**SUBJECT: RESPONSE TO QUESTIONS REGARDING CENPD-132, SUPPLEMENT 4-P, REV. 1**  
{Enclosure 1-P Contains Proprietary Information}

## **NON-PROPRIETARY RESPONSE TO NRC QUESTIONS REGARDING CENPD-132, SUPPLEMENT 4-P, REVISION 1 CALCULATIVE METHODS FOR THE CE NUCLEAR POWER LARGE BREAK LOCA EVALUATION MODEL**

**CENP Response to NRC  
Request for Additional Information (RAI)  
During Meeting on November 3, 2000  
Regarding CENPD-132-P, Supplement 4-P, Revision 1  
(TAC NO. MA5660)**

Figure 1-1  
Effect of Uncovery of the SG U-Tubes  
Peak Clad Temperature Curve

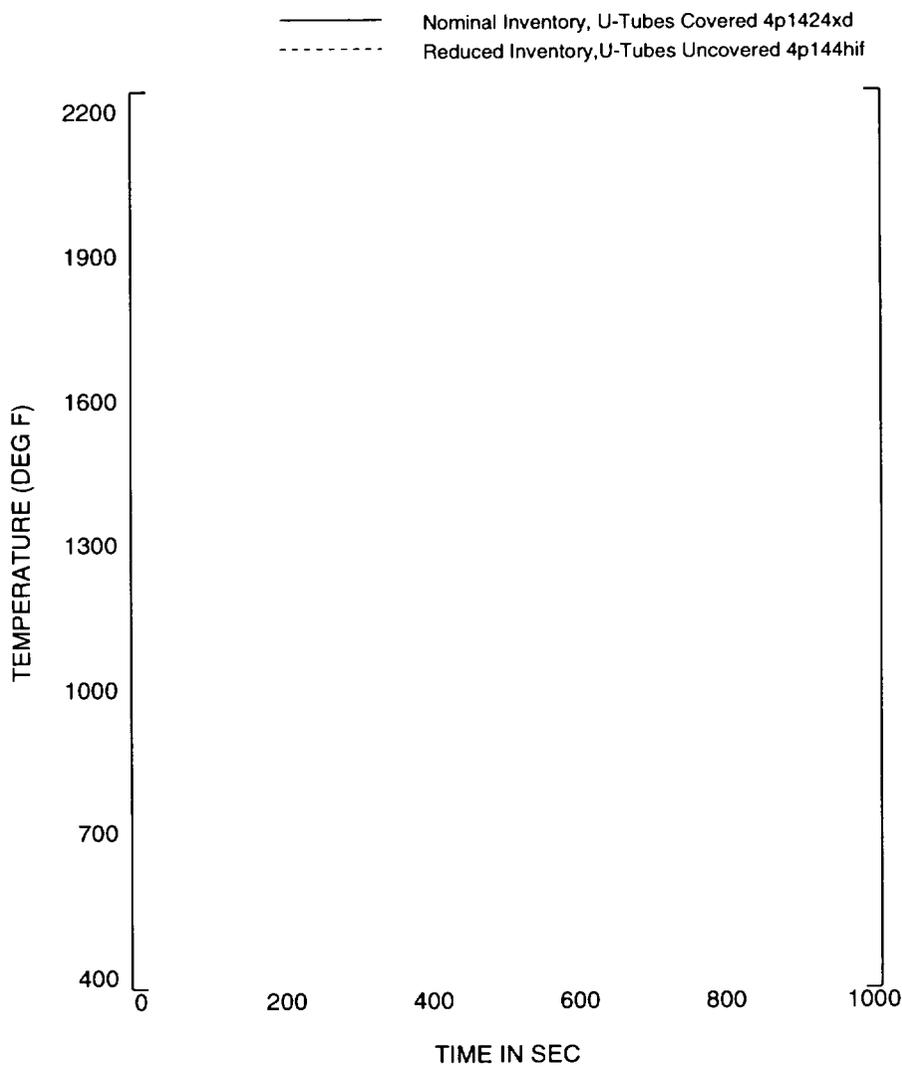
- CENP will evaluate the effects of possible U-tube uncover and provide justification for its assumption in the steam venting steam generator model that the U-tubes are covered by steam generator secondary side liquid.**

- Figure 1-1 shows that the cladding temperature transients on the limiting node (i.e., the PCT node) are [ ] between Cases 1 and 2.
- Figure 1-2 shows a comparison of the SG pressure response for Cases 1 and 2. Note that since Case 2 is run with a reduced liquid inventory, the SG pressurization during blowdown is [ ] liquid temperature at TAD. Also, the fuel average temperature of the hot rod at TAD is [ ] change in calculated blowdown hydraulics.
- Figure 1-3 shows a comparison of the SG steam temperature in the U-tubes for Cases 2 (U-tubes uncovered) and 3 (U-tubes covered) at 130 seconds into the transient. This comparison shows that the difference in temperature in the upper region of the U-tubes is [ ]. The difference at the U-tube exit is [ ] between these two cases.

Figure 2-1  
SG Secondary Side Pressure

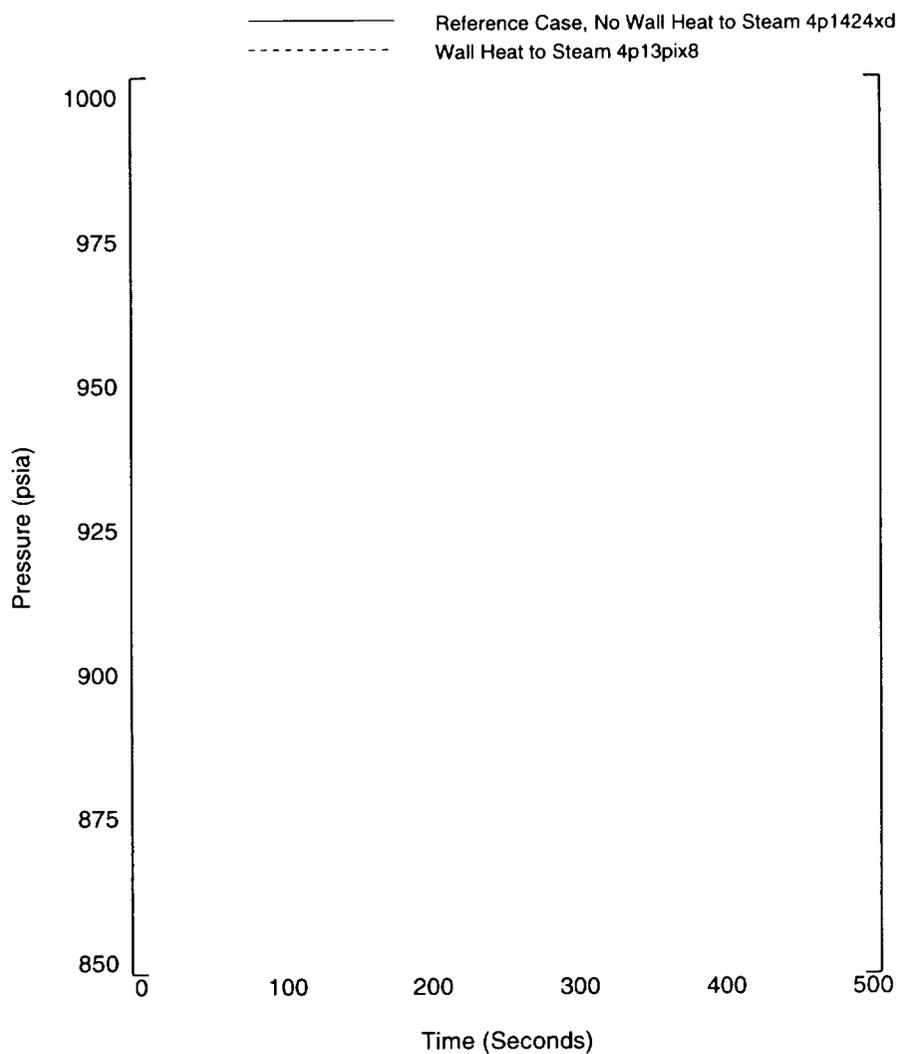
**2. CENP will evaluate the effects of neglecting the wall heat transfer to the SG secondary side steam region in the SG modeling.**

- The effect of wall heat to steam on PCT is [ .] Since the SGs are isolated at time zero, causing subsequent SG pressurization, the walls in contact with the steam act as heat sinks during the transient, absorbing heat from the secondary side and causing a [ .] The SG pressure transient comparison between the reference case (Case 1) and the case with wall heat to steam (Case 2) is shown in Figure 2-1. The secondary side wall temperature responses for the walls in contact with steam and the SG secondary side steam temperature response for Case 2 are shown in Figure 2-2.
- The combined effect of wall heat to steam and SG U-tube uncover [ .] the conclusions of the responses to Question 1. That is, the effect of the use of wall heat to steam for the case with U-tube uncover (Case 3) compared to Case 2 from Question 1 is [ .]

Figure 3.1-3  
FLECHT-SEASET Test 22010  
Secondary Side Fluid Temperature along SG Tube  
Comparison to COMPERC-II Calculation (1500 Seconds)

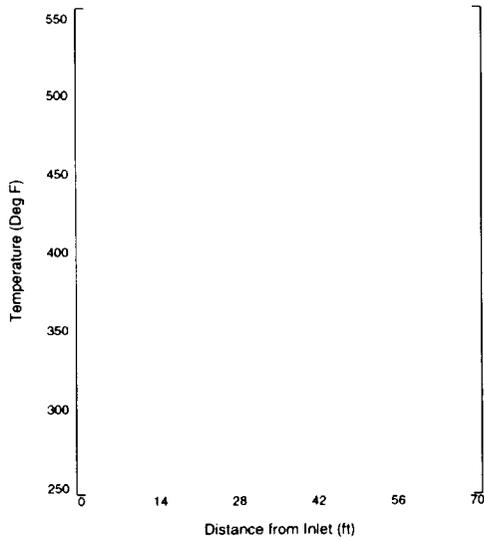
3. **CENP will provide comparisons of two additional FLECHT-SEASET separate effects test cases (Nos. 22010 and 22503) for the validation of the steam venting SG model. CENP will also provide comparisons of the primary side steam temperatures for those cases analyzed.**

*Similar to the original three tests reported in the Topical Report, the comparisons for Tests 22010 and 22503 provide results that show that the 1999 EM COMPERC-II model [ ] the measured values of the secondary side temperature both at the end of the test, see*
